# MERCUISER SERVICE BULLETIN

Number: 69-8 - D 4

Date: 1/20/69

- A. Rocker Valve Arm and Ball Squeak - MerCr. 120-160 (For Sec. VIII)
- B. Power Trim Conversion Kit (C-53108A1) (For Section X)

Figure 1. New Power Trim Panel

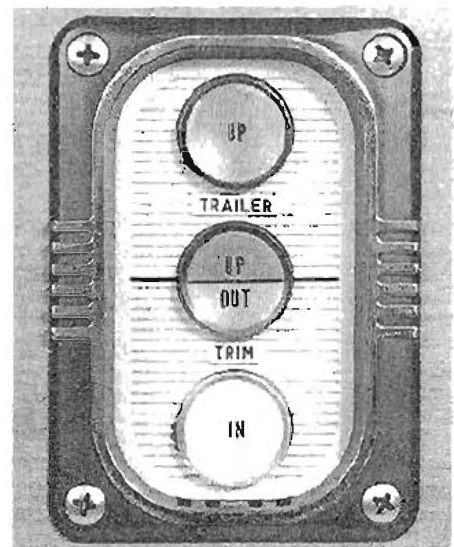
A new Power Trim Conversion Kit (C-53108A1) will convert the earlier Power Trim control panel to the new panel, as shown in Figure 1.

Trim operation of the new Power Trim panel will keep the drive within trim operating limits when the "UP/OUT" trim button is depressed. This feature prevents the drive from being trimmed accidentally into a trailer position, unless both the "UP" and "UP/OUT" buttons are depressed simultaneously.

Refer to MerCruiser Service Bulletin No. 69-1, Paragraphs "F" and "G", dated 10/10/68, for operation of the new Power Trim panel.
